Seeley Fire Station and Cooling Center

County Project No. SR49337

ADDENDUM NO. 2

NOVEMBER 29, 2022

| PROJECT TITLE: SEELEY FIRE STATION & COOLING CENTER | SHEET A3.00 |

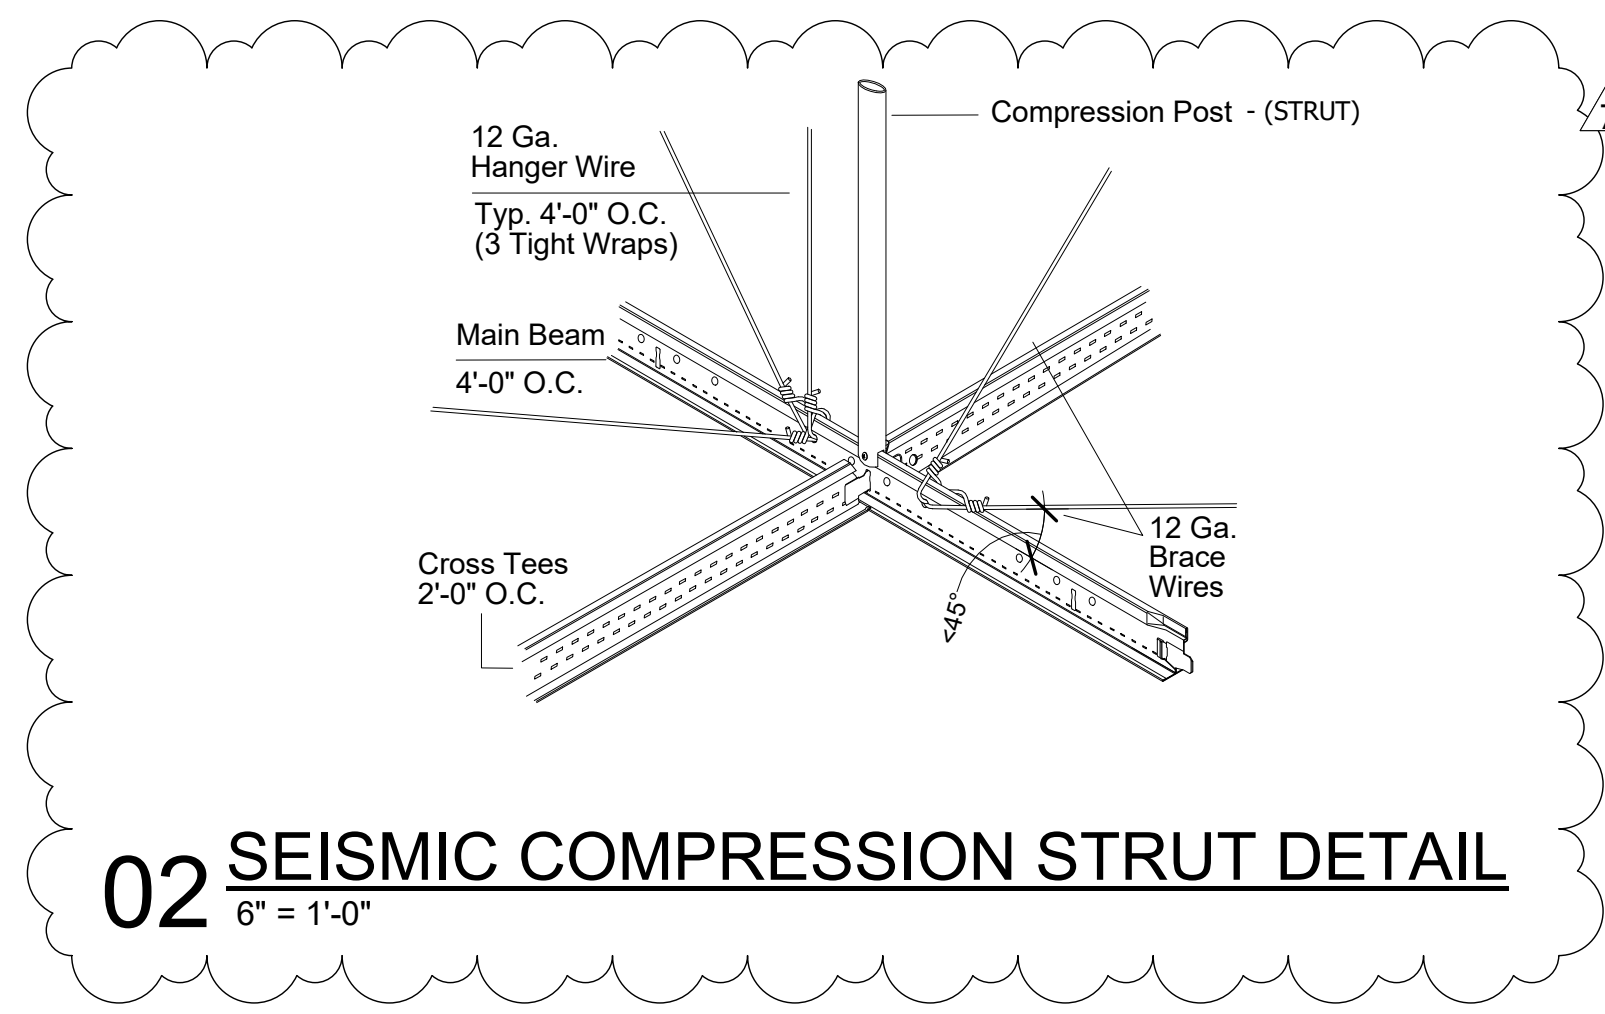
The Bid Set Plan Sheet Numbers: *A.00, A3.00, A3.30, A4.00, A7.00, A7.20 and A9.20* are hereby deleted and replaced with the revised attached plan sheet numbers *A.00, A3.00, A3.30, A4.00, A7.00, A7.20 and A9.20*

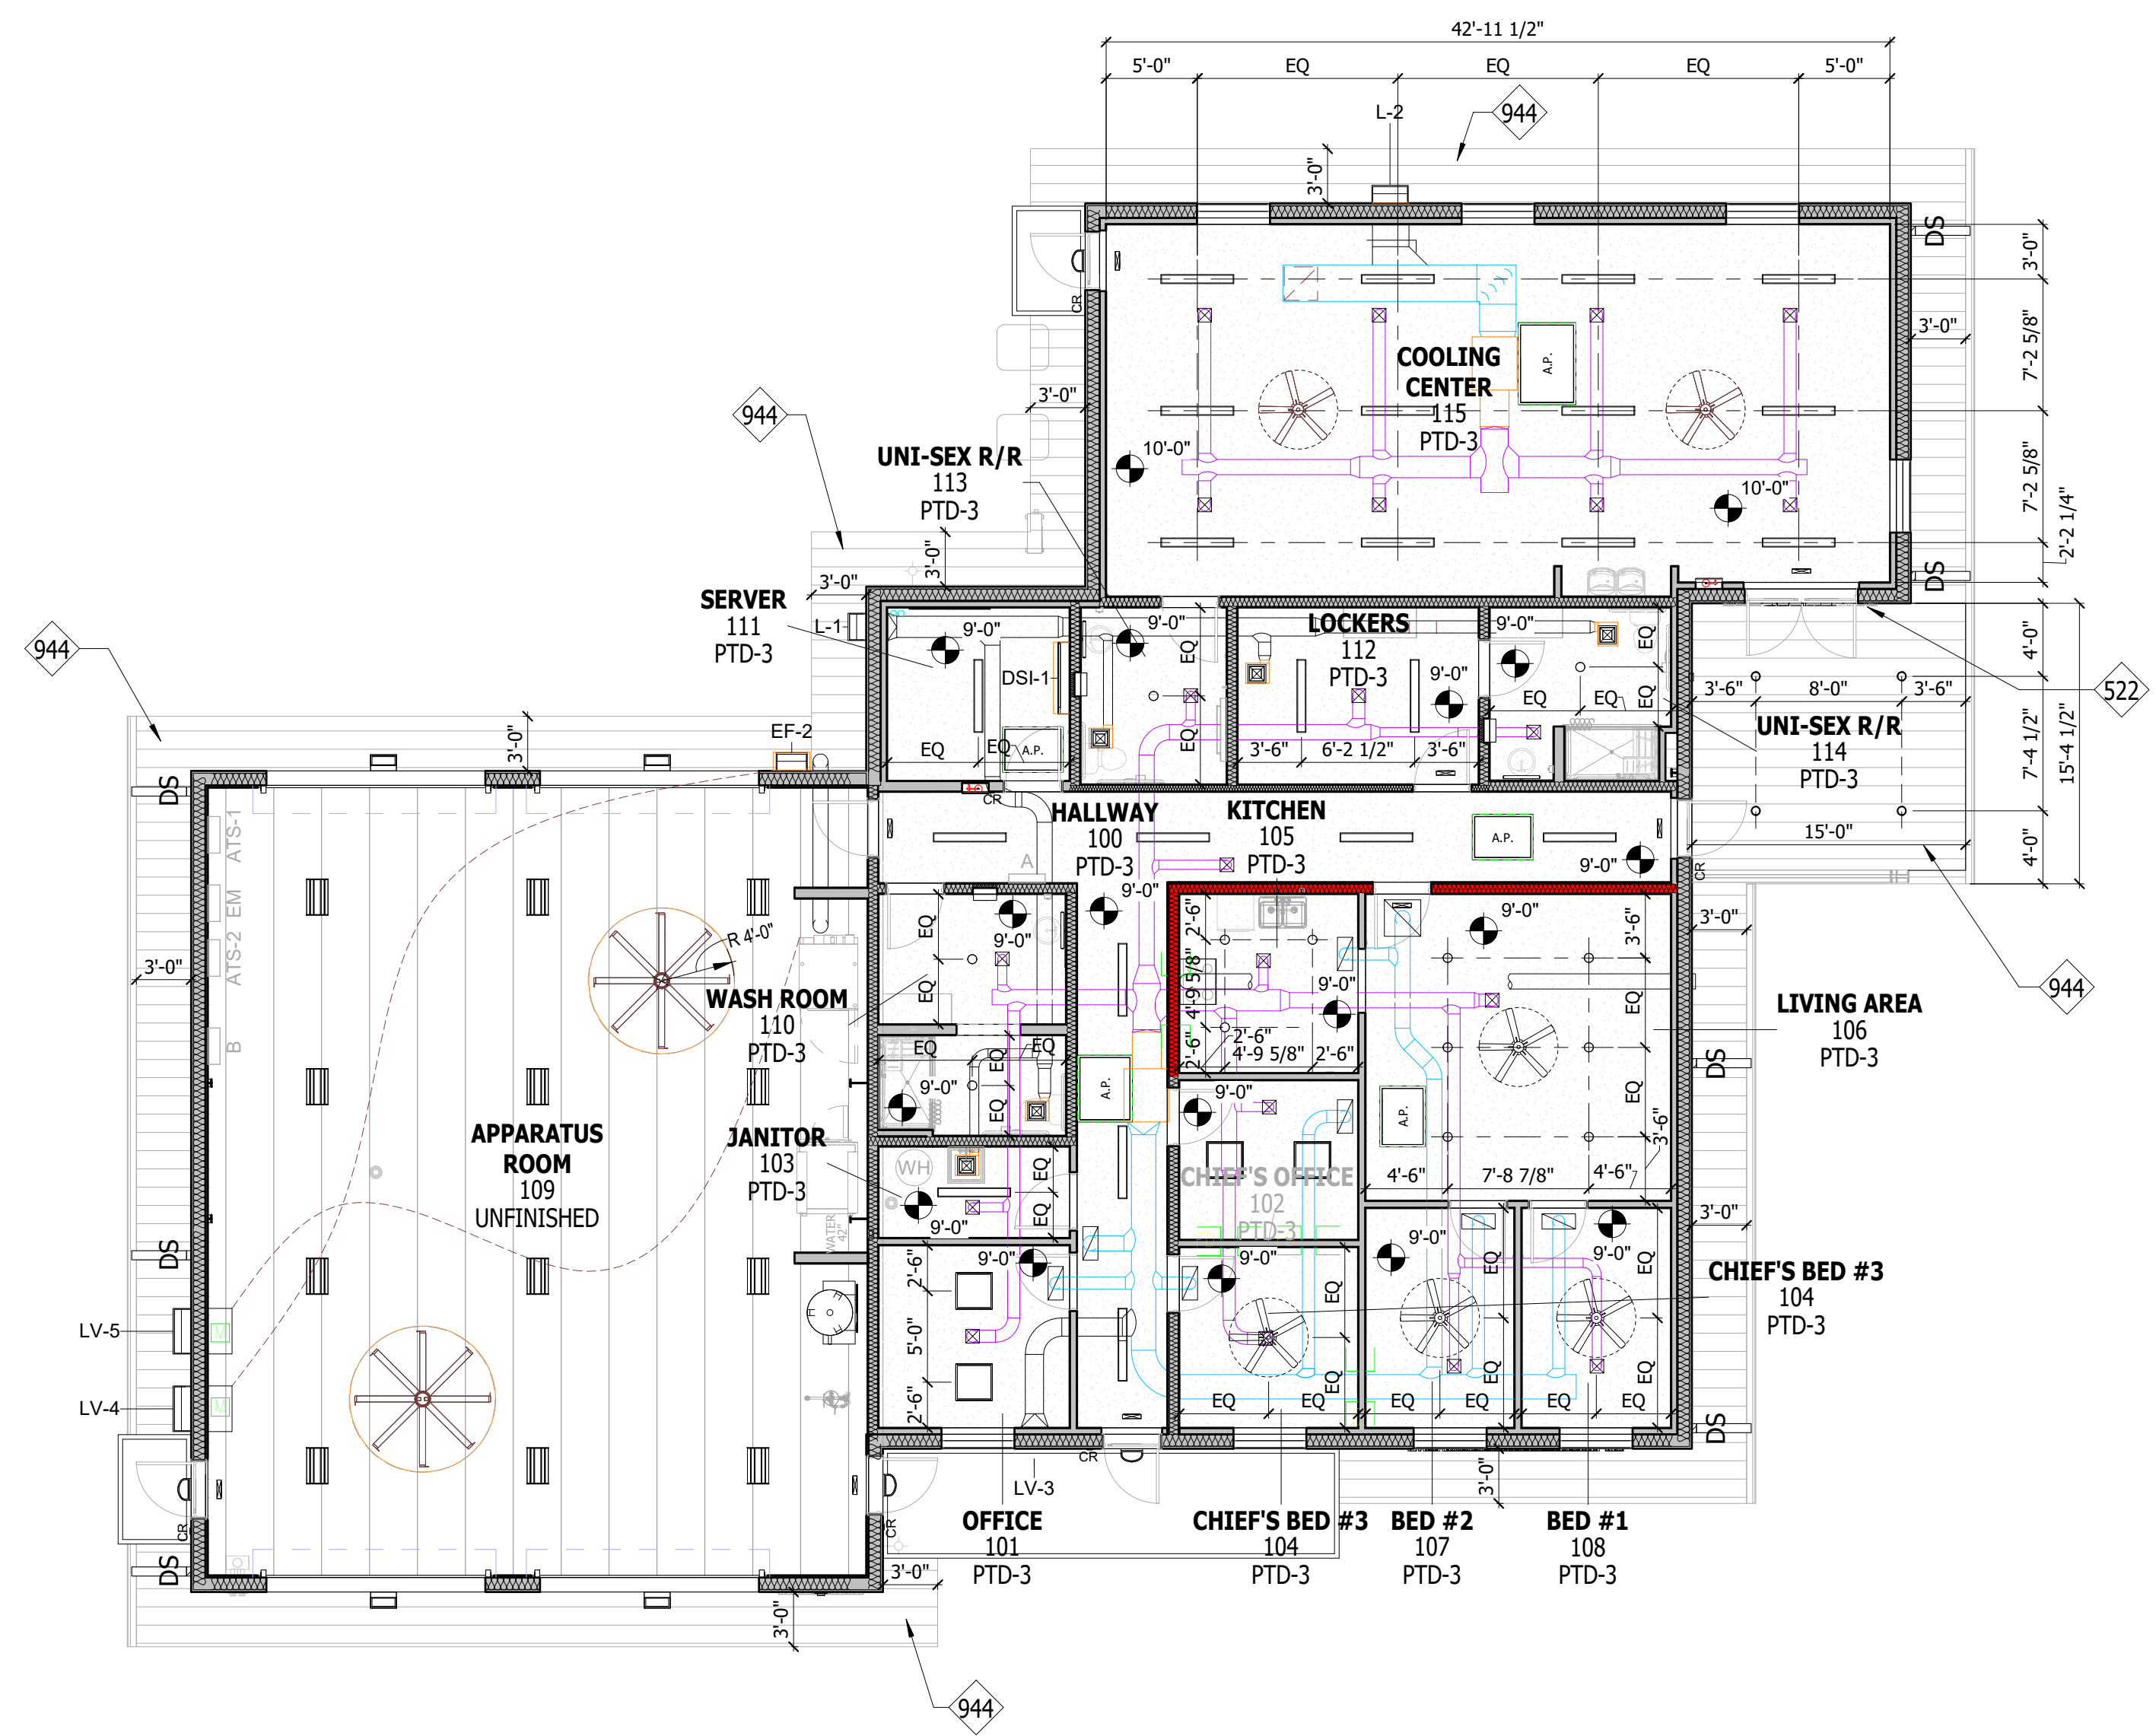
Question 40: **Provide correct structural details for seismic strut and hangers to be used with specified roof insulation system**

Response: Please refer to revised plan sheet A4.00 within Addendum No. 7, for added detail #02 that illustrates ceiling bracing notes. Struts to be connected to metal building purlins above.

CEILING BRACING SHALL BE PROVIDED BY FOUR NO. 12 GAUGE WIRES SECURED TO THE MAIN RUNNER WITHIN 2 INCHES OF THE CROSS RUNNER INTERSECTION AND SPAYED 90 DEGREES FROM EACH OTHER AT AN ANGLE NOT EXCEEDING 45 DEGREES FROM THE PLANE OF THE CEILING

A STRUT (ADEQUATE TO RESIST THE VERTICAL COMPONENT FROM LATERAL LOADS) FASTENED TO THE MAIN RUNNER SHALL BE EXTENDED TO AND FASTENED TO THE STRUCTURAL MEMBERS OF THE ROOF ABOVE. THESE HORIZONTAL RESTRAINT POINTS SHALL BE PLACED 12 FT. ON CENTER IN BOTH DIRECTIONS WITH THE FIRST POINT WITHIN 6 FT. OF EACH WALL. ATTACHMENT OF THE RESTRAINT WIRES TO THE STRUCTURE ABOVE SHALL BE ADEQUATE FOR THE LOAD IMPOSED
